Quality Control Check Report

Flat No. A-706 Stage: After Finishing Stage III (Apartments)

Company MPL Project 38206

Details of Additions & Alterations

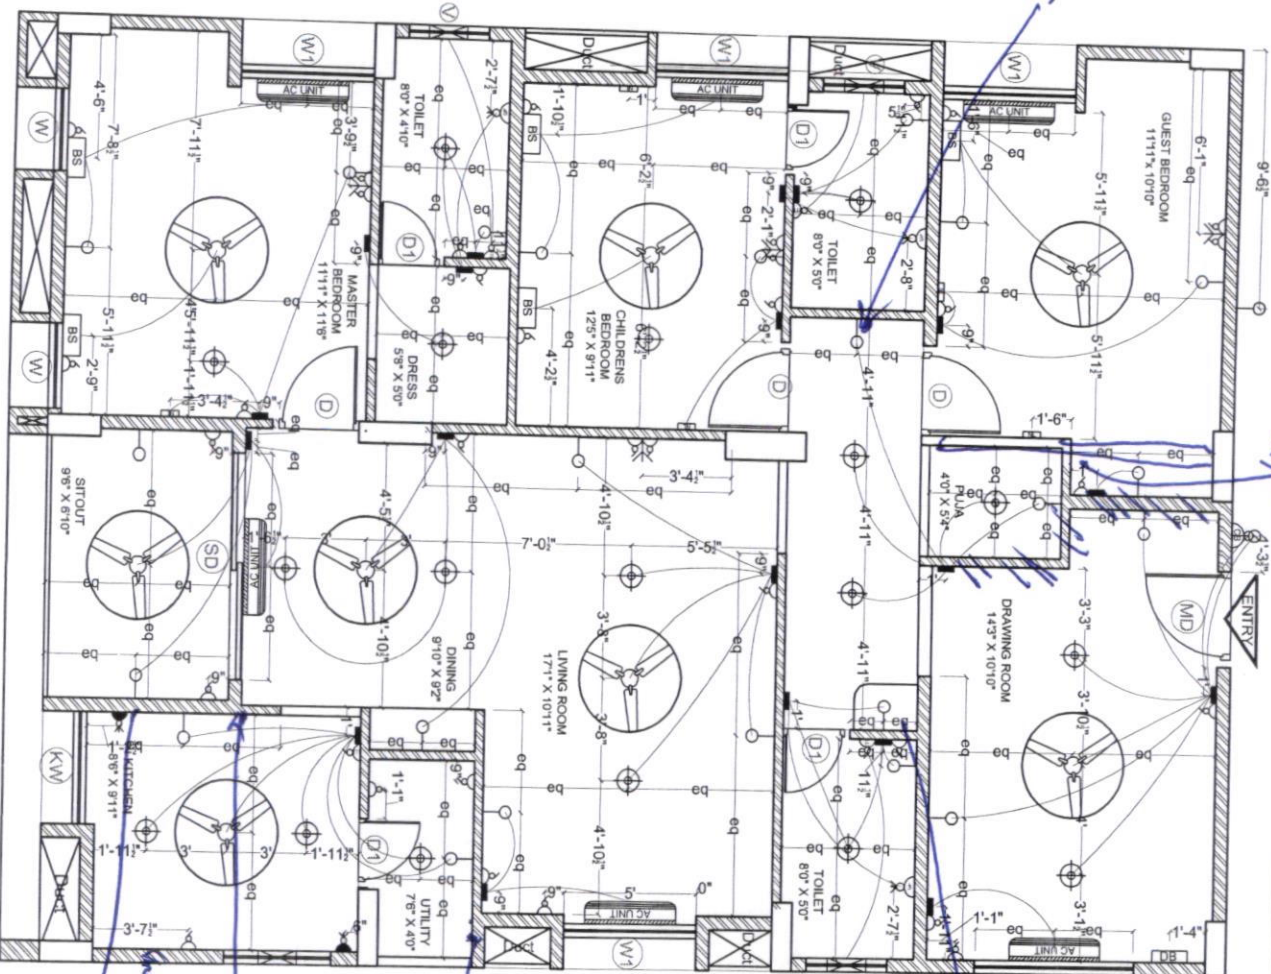
Changes in electrical points: (mark on plan)

- ① Work has done 5amps pt & 15amps pt in all bathrooms.
- ② TV pt in drawing area
- ③ 15amps pt extra in utility, kitchen marked on plan.
- ④ 5amps pt in drawing passage marked on plan.

Changes in kitchen platform: (mark on plan)

Other Changes:

① Design cerky same as A-106 model
flat in drawing, living & dining area &
plain cerky in all bedrooms.

② wall to be extended of utility
wall as marked on plan.

③ puja wall to be removed as
marked on plan.

④ MBR wall to be removed &
marked on plan.

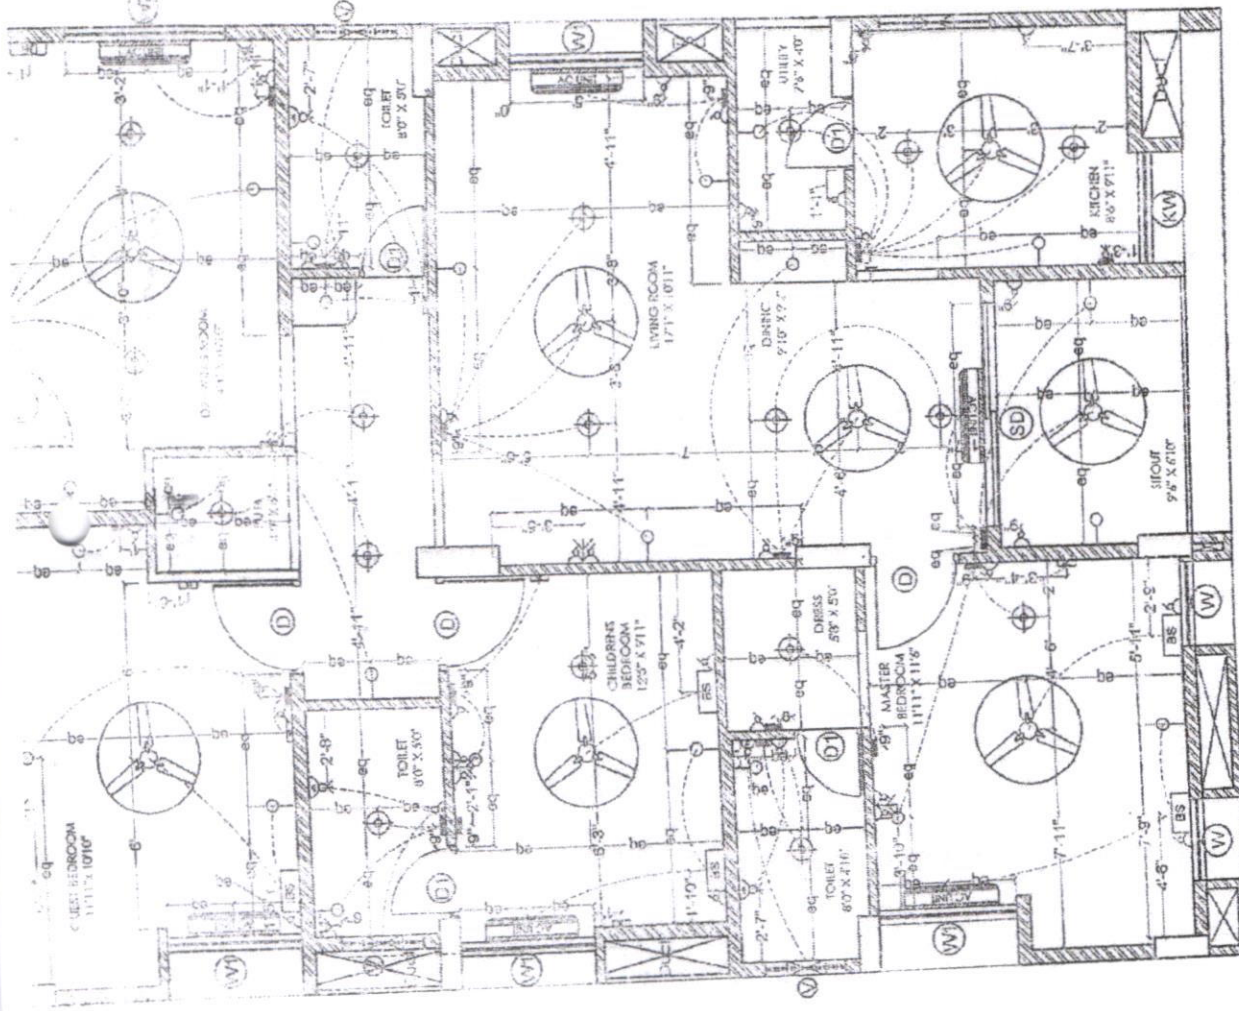
2. In C. Bed & G. Bed TV point is provided with 3'-9" instead of 3'-6".								
Remarks on additions & alteration sheet:								
Signed by engineer,		☒ Yes ☐ No		Signed by customer,		☒ Yes ☐ No		
Revised drawing required from HO		☐ Yes ☐ No		Approved revised drawing attached		☐ Yes ☐ No
